**Re: Data Adequacy Supplement, Rice Solar Energy Project (09-AFC-10)
Application for Certification**

Supplement

In Response to Data Adequacy Review

Rice Solar Energy Project

FIGURE DA3.0-1
DESIGN DIAGRAM FOR THE DEAD-END
STRUCTURES OF THE GENERATOR TIE-LINE
 Rice Solar Energy Project
 Riverside County, California

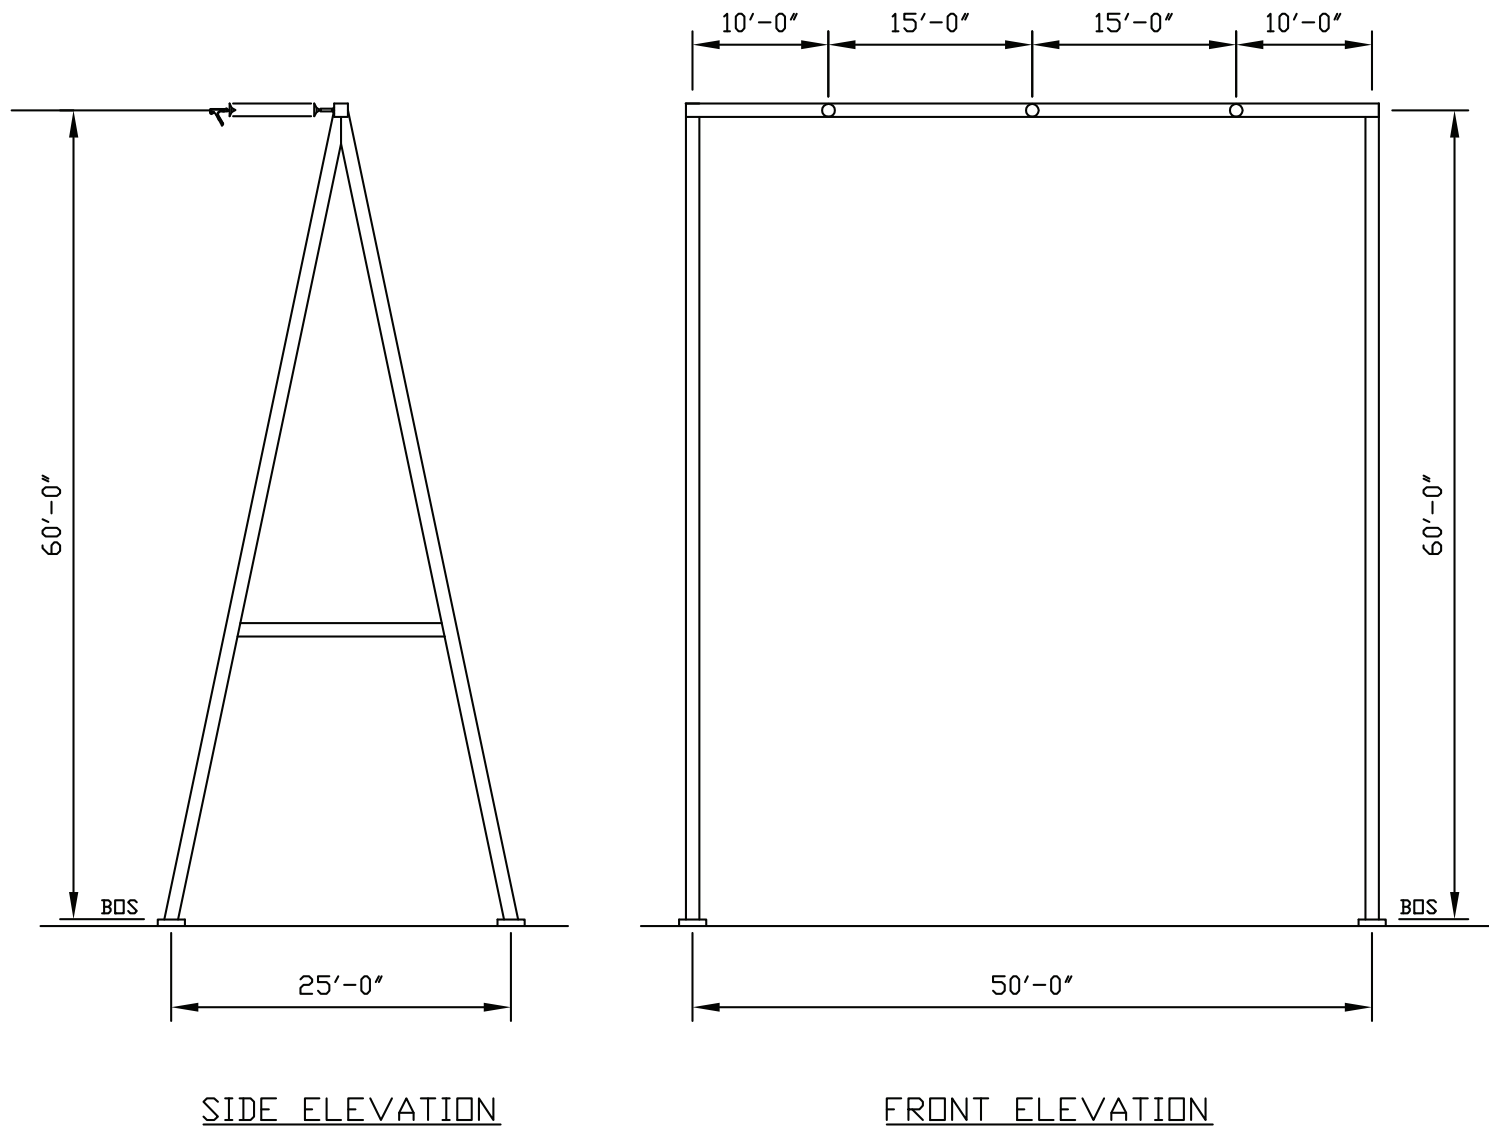
- a) *Please submit a Pole design diagram for dead-end structures of the generator overhead 230 kV tie lines showing configuration of insulators and conductors with their respective position measurements on the pole. Provide tie line conductor size, type and ampere rating.*

- a) Attachment DA3.0-1 is a pole design diagram for the dead-end structures of the generator tie-line.
- b) The correct generator voltage rating is 18 kV.
- c) Regarding Figure 2.2-4:
 - 1. It is not necessary to revise the voltage ratings of the generator and generator step-up transformer low and high sides. The figure is correct.
 - 2. The low voltage bus ducts and generator breaker ratings have been revised and are reflected in Figure DA3.0-2, which is a revised version of Figure 2.2-4.
 - 3. Figure DA3.0-2 is a revised version of Figure 2.2-4 that correctly rates the bus duct sizes and ampere ratings of the short overhead conductors between the generator step-up transformer high side and the generator tie-line take-off structures.

FIGURE DA3.0-2
REVISED POWER PLANT SWITCHYARD
ONE-LINE DIAGRAM
 Rice Solar Energy Project
 Riverside County, California

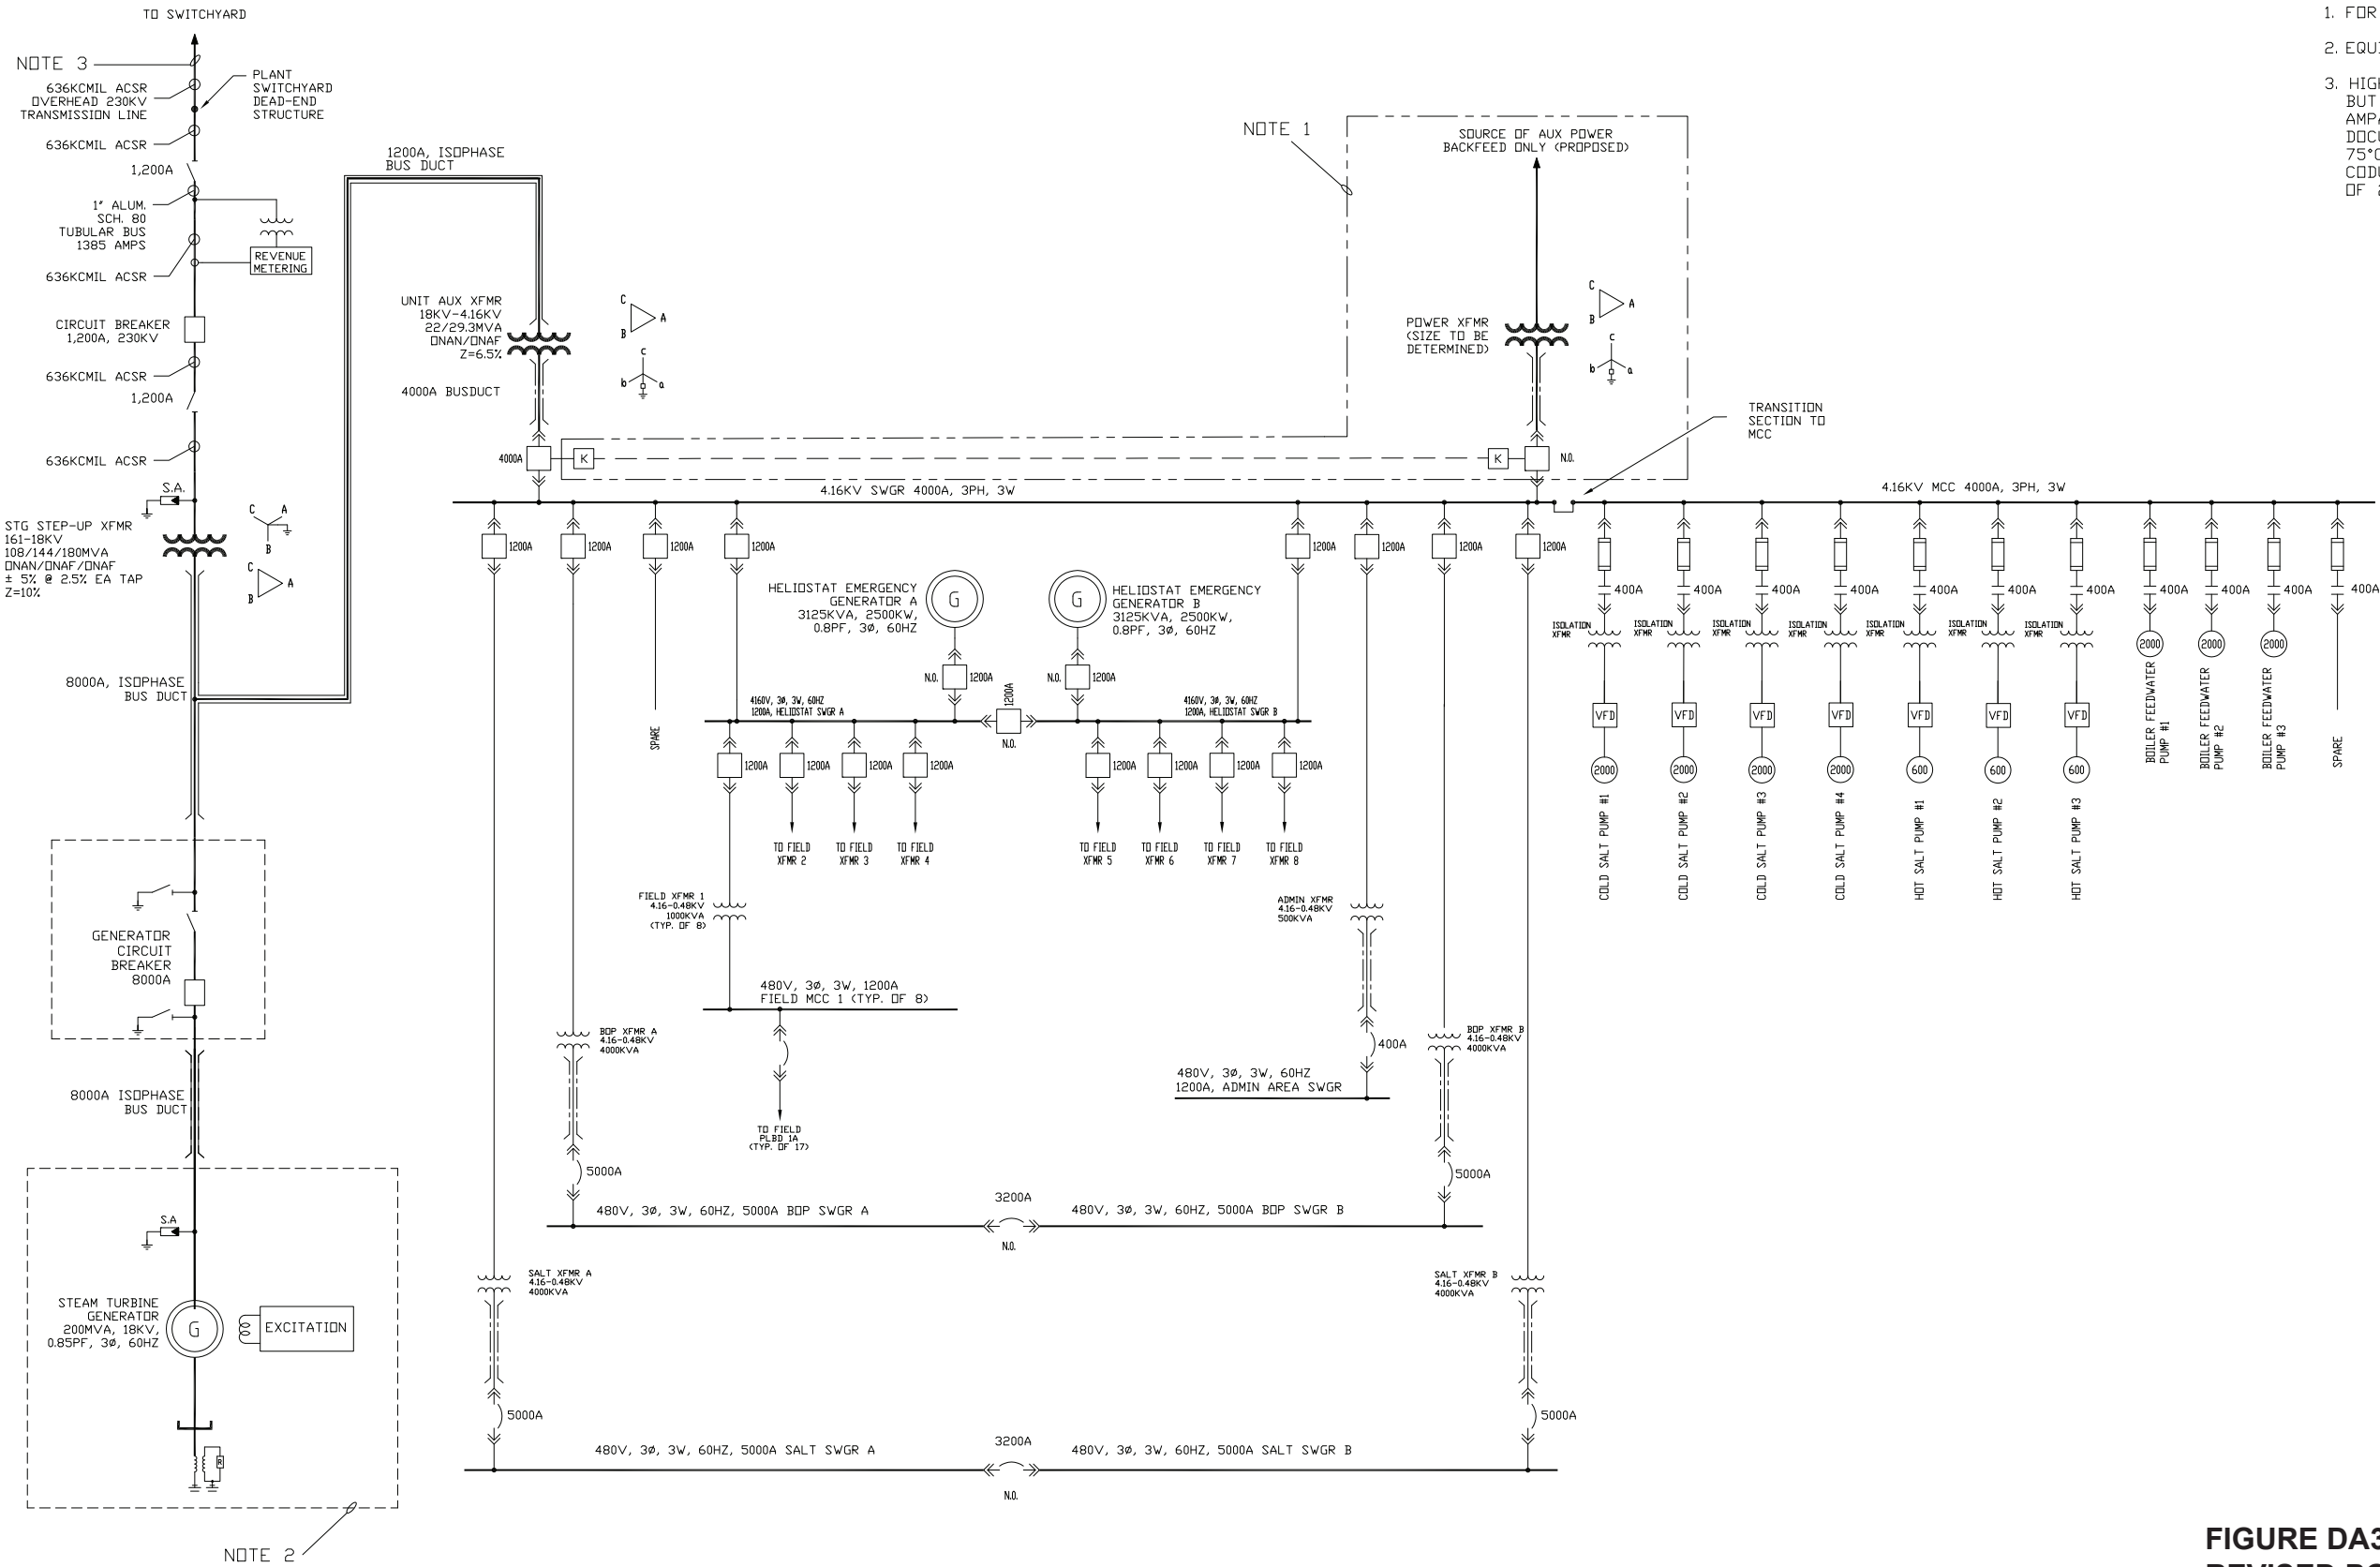
- b) *Please provide the generator voltage rating (13.8 kV or 18 kV), since a discrepancy is observed between the description and the Figure 2.2-4.*
- c) *Resubmit Figures 2.2-4 with the following:*

- 1. *Revised voltage ratings of the generator and the generator step-up transformer both low and high sides (high side shown as a single 161 kV instead of a dual voltage), if necessary.*

- 2. *Revised ampere ratings of low voltage bus ducts and generator breaker, if necessary.*
 - 3. *Sizes and/or ratings of the short overhead conductors and/or cables between the generator step-up transformer high side and the 230 kV generator tie line take-off structures via the 230 kV switchyard breaker.*

FIGURE DA3.0-3
REVISED INTERCONNECTION
SWITCHYARD ONE-LINE DIAGRAM
Rice Solar Energy Project
Riverside County, California

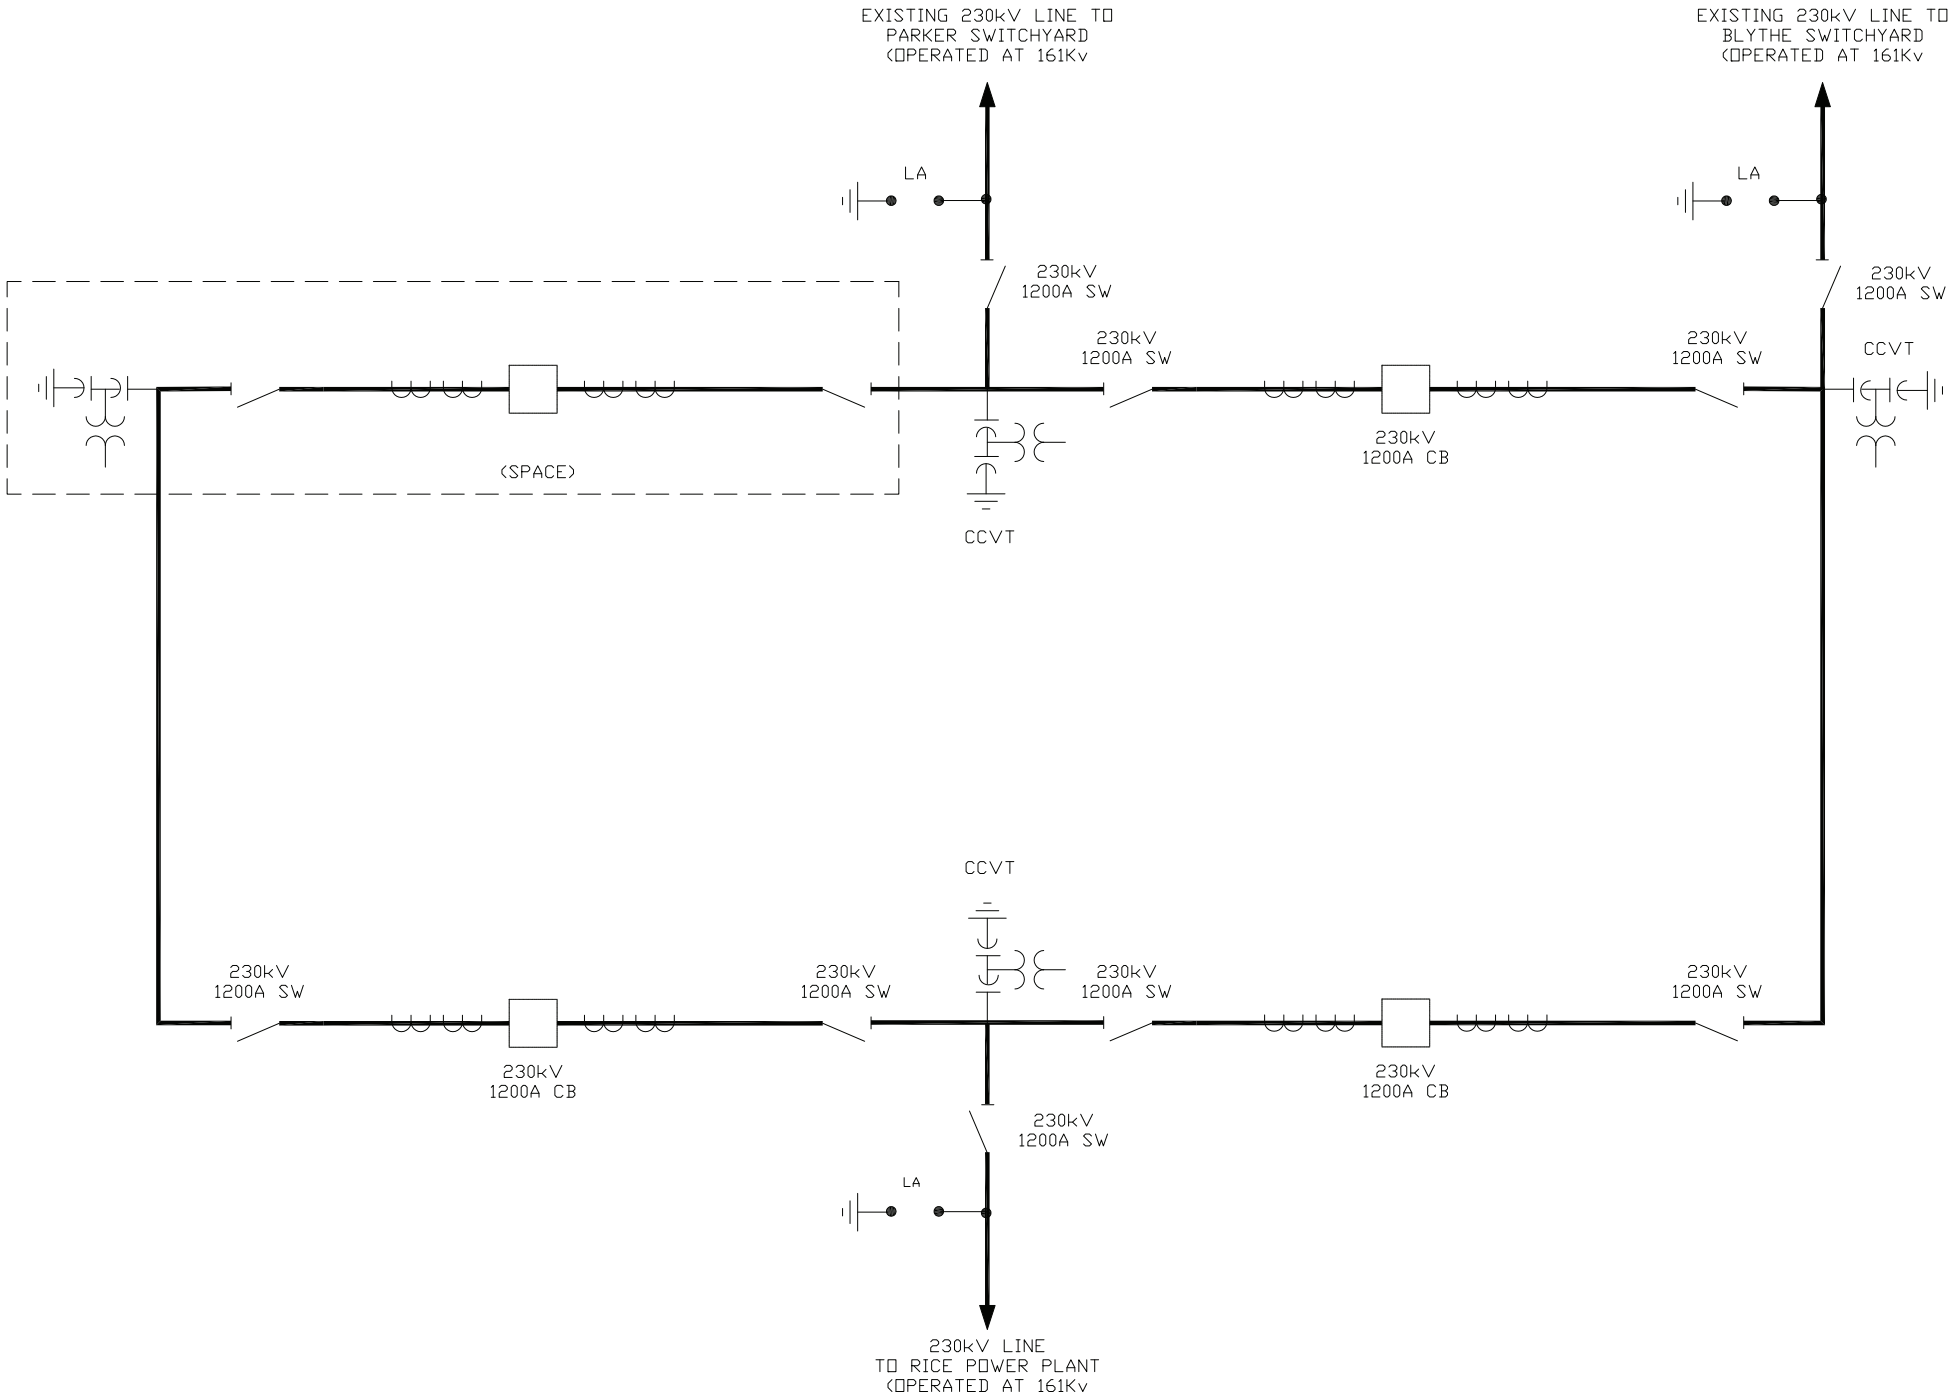
- d) *Please Resubmit Figure 3.1-2 with 230 kV bus size, type and ampere rating.*

d) Figure DA3.0-3 is a revised and corrected version of AFC Figure 3.1-2.
